Subject: Draft Housing Element and related 4-4-22 zoning text amendments (Item 7-C on 4-19-22 City Council agenda)

Subject: Housing Element updates

Re: Alameda Housing Element Update and Related Density Bonus Issues

Initial List of changes to *April Draft Housing Element* and *April Draft Zoning Amendments*:

2. Building Height Limit: Building height shall be regulated as follows:

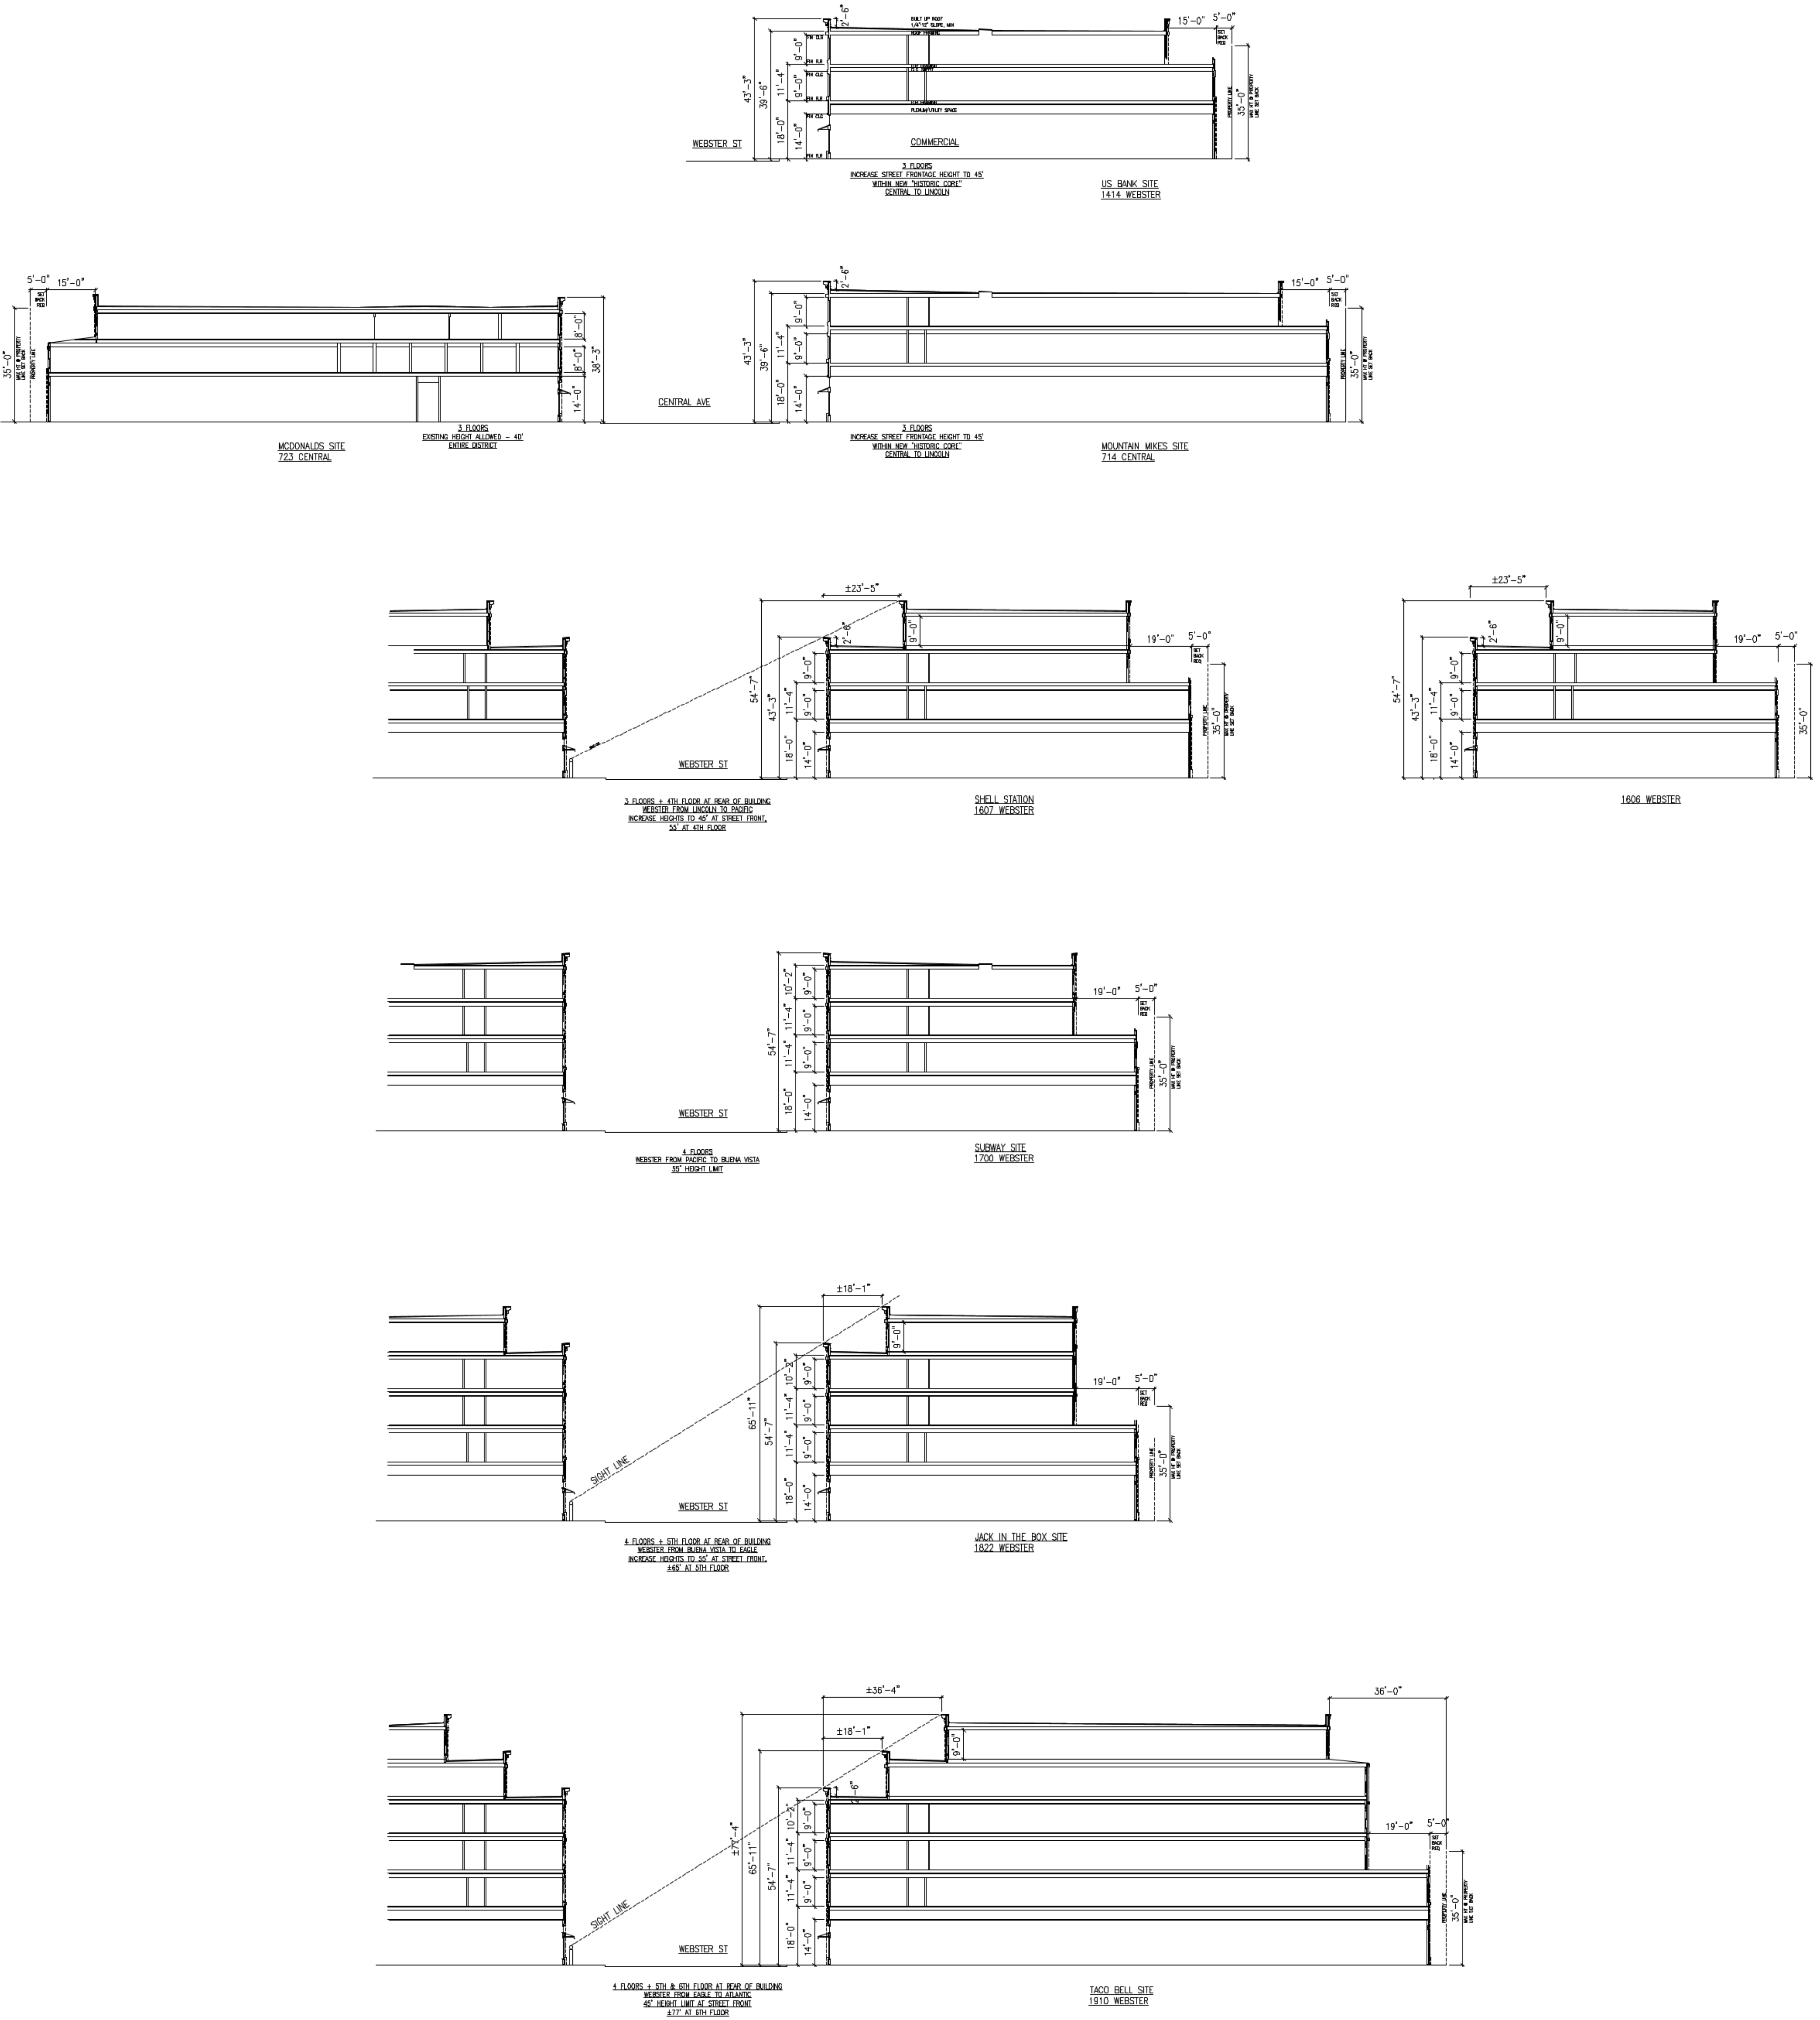
Park Street District—Maximum height shall be ~~five (5) stories but not to exceed sixty (60') feet.~~ for properties fronting on Park Street north of Encinal Avenue. In the remaining areas of the Park Street C-C District the height limit shall be forty (40') feet and the height within this area may be increased to a maximum of sixty (60') feet upon approval of a use permit. Parking structures, including parking structures which have a commercial use component, are exempt from the height limit provided the structure does not exceed six (6) stories, the commercial floor area does not exceed fifty (50%) percent of the overall floor area of the structure, and public parking is provided in addition to the parking required for the commercial component.

Webster Street District—Maximum height shall be as follows: ~~three (3) stories but not to exceed forty (40') feet throughout the C-C District~~

- Properties fronting onto the south side of Central Avenue - fifty five (55') feet, provided that any portion of the building that exceeds forty five (45') feet is set back at least ten (10') feet from the face of the building.
- Properties fronting onto Webster Street between Central Avenue and Lincoln Avenue, and properties fronting onto the north side of Central and south side of Lincoln - forty five (45') feet;
- Properties fronting onto Webster Street between Lincoln Avenue and Pacific Avenue and properties fronting onto the north side of Lincoln and the south side of Pacific - fifty five (55') feet, provided that any portion of the building that exceeds forty five (45') feet is set back at least ~~ten (10')~~ feet from the face of the building;

- Properties fronting onto Webster Street between Pacific Avenue and Buena Vista Avenue and properties fronting onto the north side of Pacific and the south side of Buena Vista Avenue - fifty five (55') feet; (SAME 24' SET BACK? & REAR?)

- Properties fronting onto Webster Street between Buena Vista Avenue and Eagle Avenue and properties fronting onto the north side of Buena Vista or the south side of Eagle- sixty five (65') feet, provided any portion of the building that exceeds fifty five (55') feet is set back at least ~~ten (10')~~ ^{18'} feet; and, (+ 24' SET BACK & REAR FT?)

- Properties fronting onto Webster Street between Eagle Ave and Atlantic Avenue and properties fronting onto the north side of Eagle or south side of Atlantic- ~~eighty five (85') feet.~~ ^{80' (85') feet. w/ 18' SET BACK @ 5th FLR + 36' SET BACK @ 6th FLR + 24' @ REAR}
